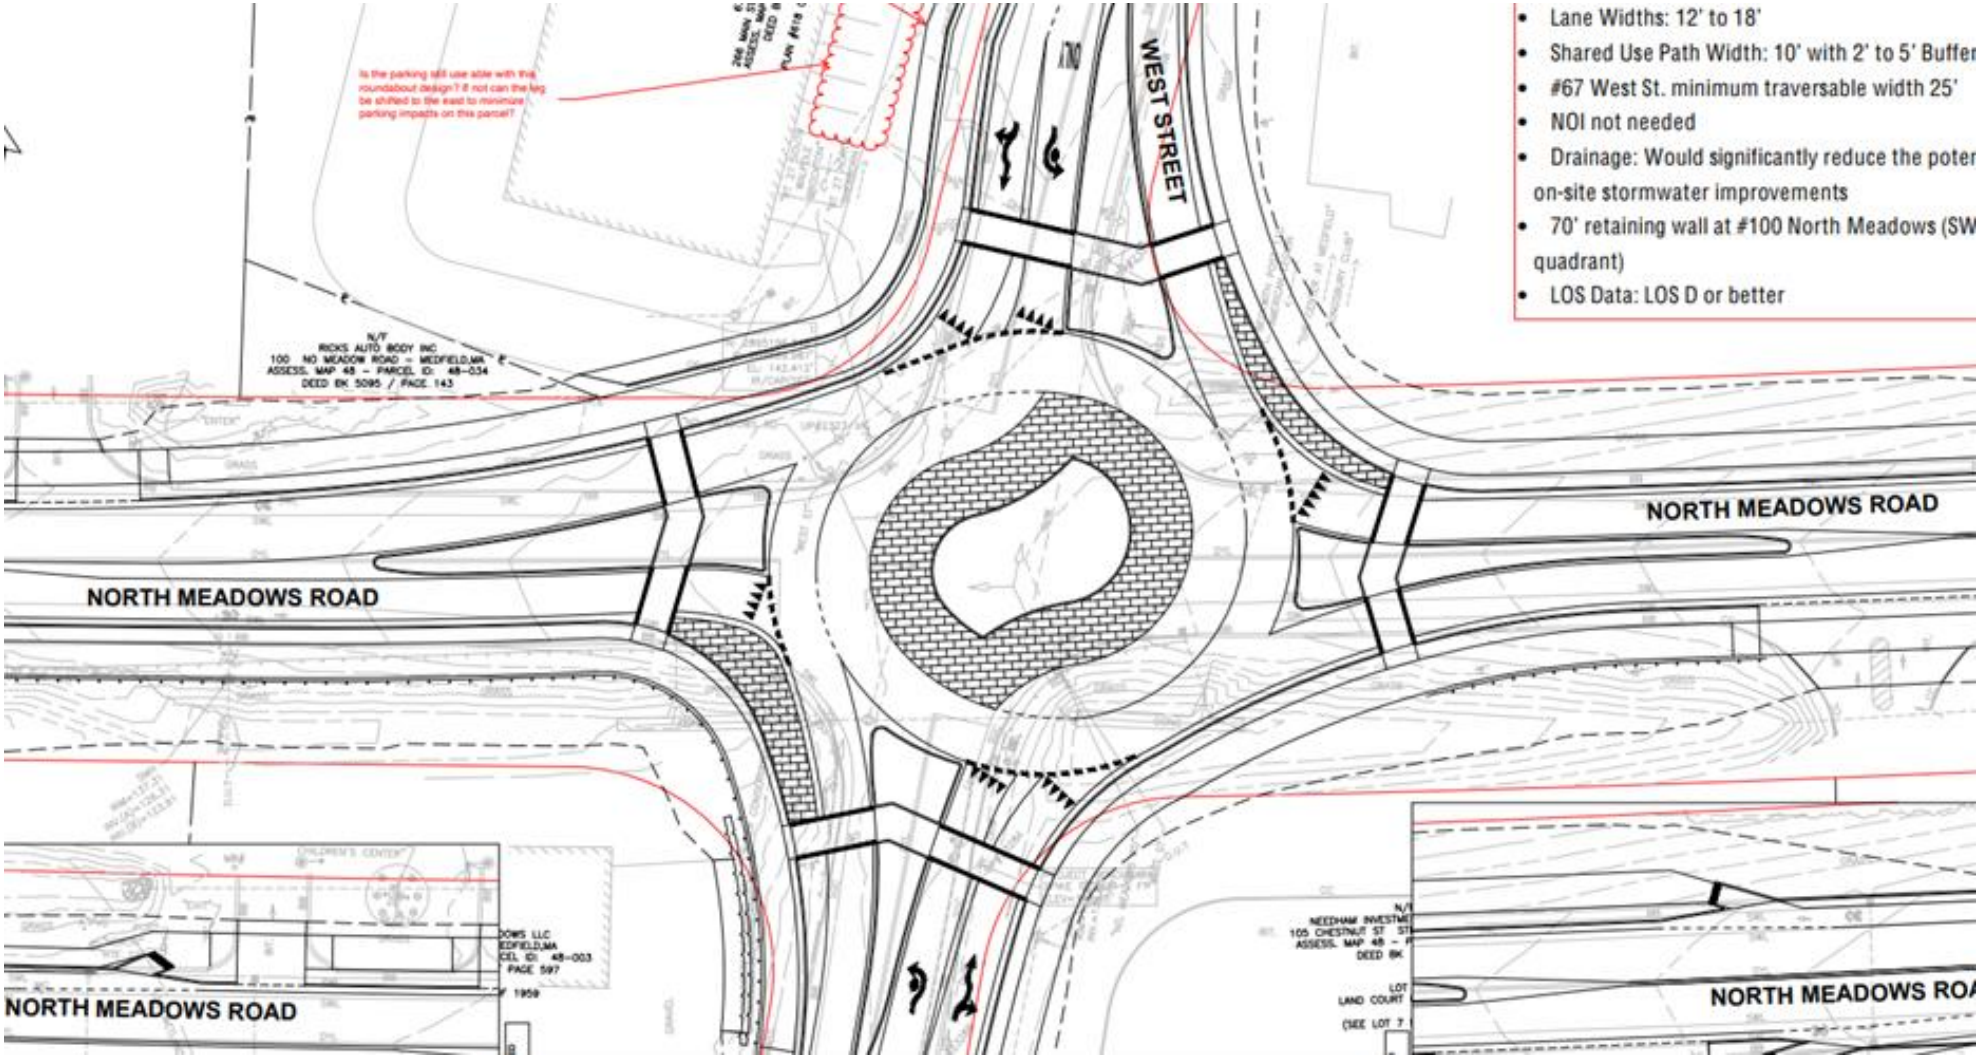
Is the parking still use able with this roundabout design? If not can the leg be shifted to the east to minimize parking impacts on this parcel?
WEST STREET
NORTH MEADOWS ROAD
NORTH MEADOWS ROAD
NORTH MEADOWS ROAD
NORTH MEADOWS ROA
N/F
RICKS AUTO BODY INC
100 NO MEADOW ROAD - MEDFIELD,MA
ASSESS. MAP 48 - PARCEL ID: 48-034
DEED BK 5095 / PAGE 143
Lane Widths: 12' to 18'
Shared Use Path Width: 10' with 2' to 5' Buffer
#67 West St. minimum traversable width 25'
NOI not needed
Drainage: Would significantly reduce the poter on-site stormwater improvements
70' retaining wall at #100 North Meadows (SW quadrant)
LOS Data: LOS D or better
